Report to Planning and Environment Committee

Subject: 1407 - 1427 Hyde Park Road (at South Carriage Road)
(OZ-9438/York Developments)

Public Participation Meeting on: September 12, 2022

Figure 1 – Conceptual Site Plan

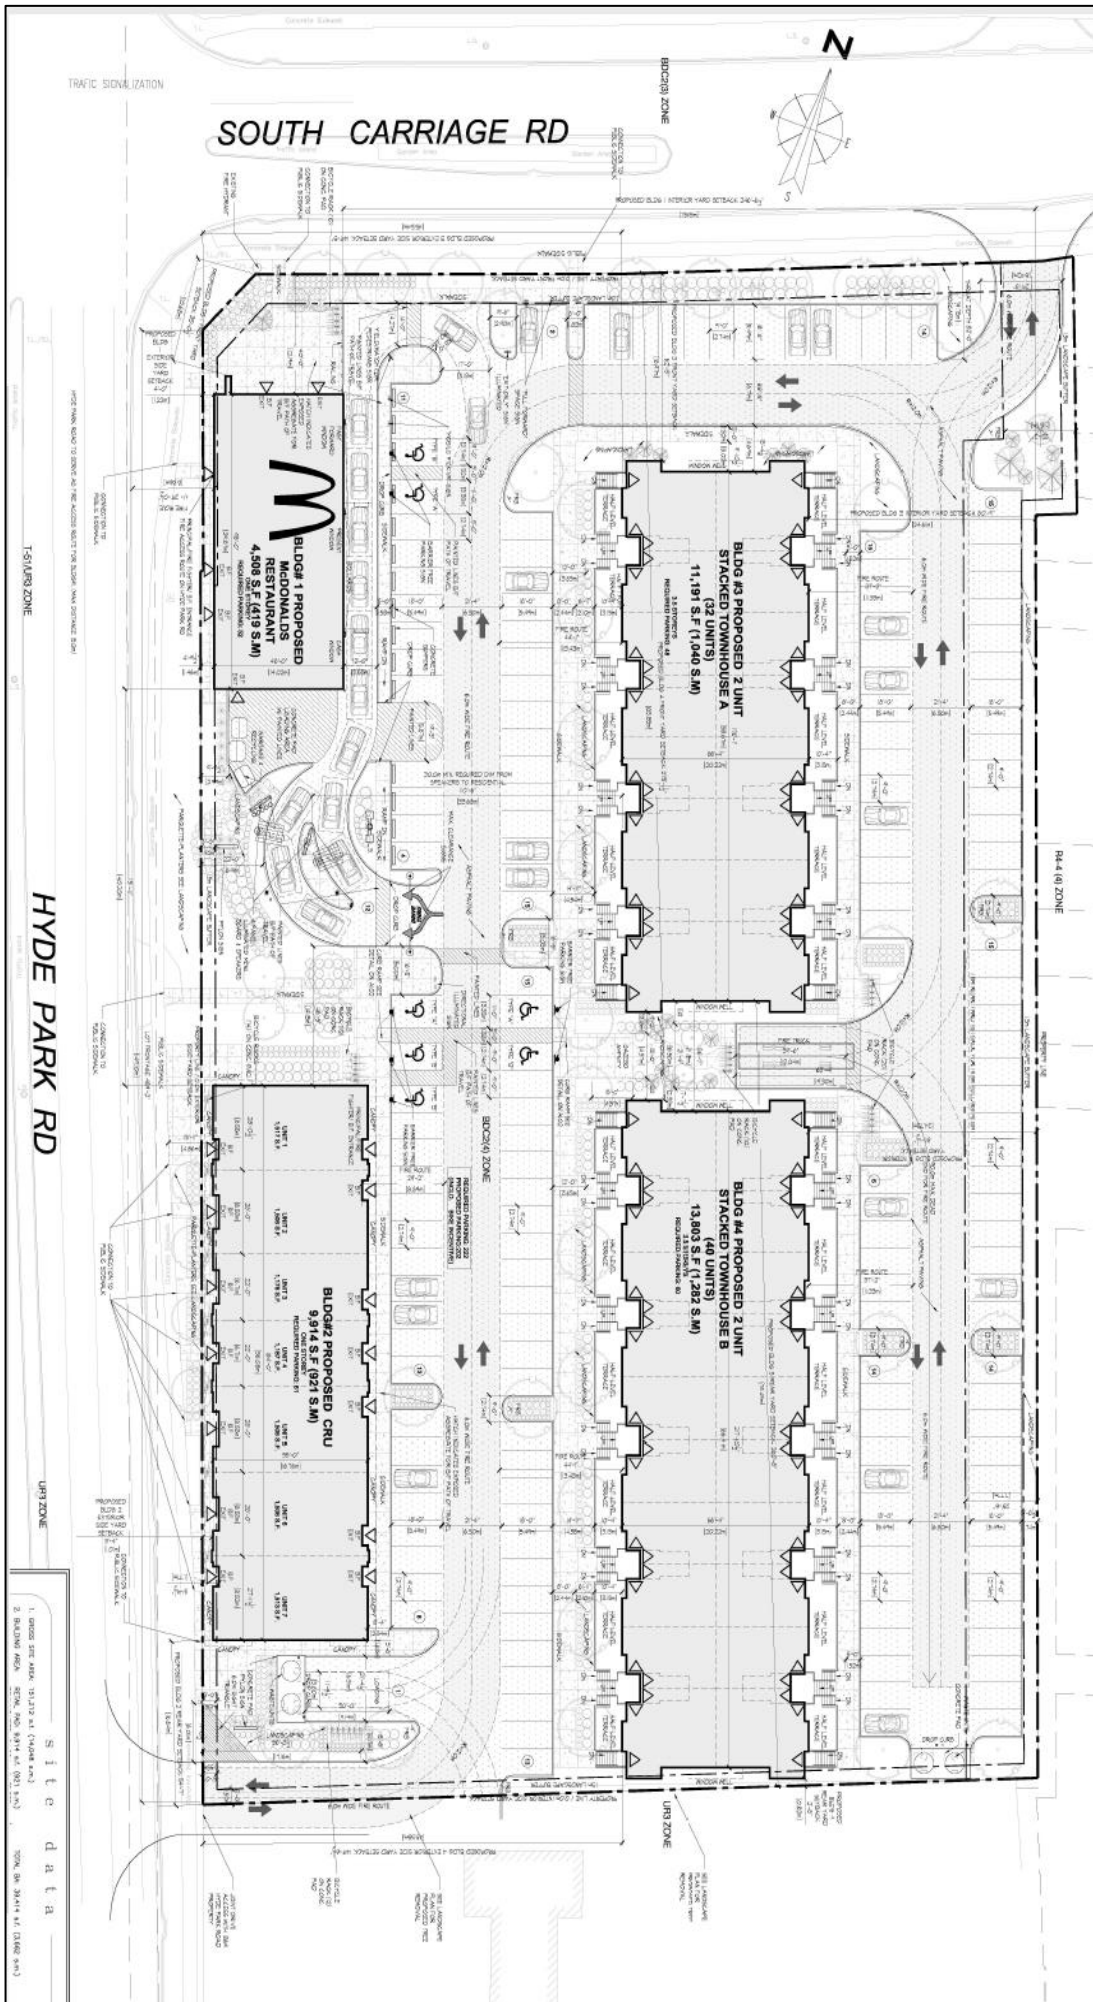
Both the Site Plan Approval and Urban Design Sections of the Planning and Development Department and the Urban Design Peer Review Panel (UDPRP) had significant concerns about the design of the proposed development and its ability to meet the intent of the Main Street Place Type policies in The London Plan.

1. The commercial building and the restaurant along Hyde Park Road are only one storey in height, the policies require a minimum of two storeys (London Plan Policy 908_2);

2. Remove the drive-through;
3. Separate commercial and residential parking areas;
4. Rotate Building 3 along South Carriage with parking behind with a 75% street wall frontage. The proposed parking along South Carriage should be removed;

5. No parking shall be located between the street frontages and the building face (The London Plan Policy 911-9) and screen all surface parking areas;
6. Ensure the proposed built form at the intersection emphasizes and addresses the corner location (The London Plan Policy 291);

7. Design the space between the building and the Right-of-Way so it is similar to other developments in the area with a main sidewalk, secondary sidewalk and large planting beds;

- Design a mixed-use building (minimum 2 floors and maximum 6 floors) with ground floor commercial and residential units on upper floor along Hyde Park Road **[TLP 908-2]**. This will help in creating an appropriate street enclosure and pedestrian realm relative to street width and a main street urban form resolving other site plan issues like parking, outdoor amenity spaces, etc.
- Alternatively, split "Building 2" into two buildings with parking located between the two buildings to allow for better access to the commercial units along the Hyde Park Road frontage from the parking area.

- The Panel recommends that the site design be revised to focus a more prominent built form (e.g., 2-storey buildings min.) along the Hyde Park Road frontage in order to create the desired sense of enclosure for the main street pedestrian realm and appropriately relate to width of the adjacent ROW.

- Provide an adequately sized and functional amenity space for the residential units.
- Locate the site access wholly on the subject property.
- Drive-through stacking spaces are counted from the window where customers pick up their orders. Confirm the purpose of the "fast forward" window.
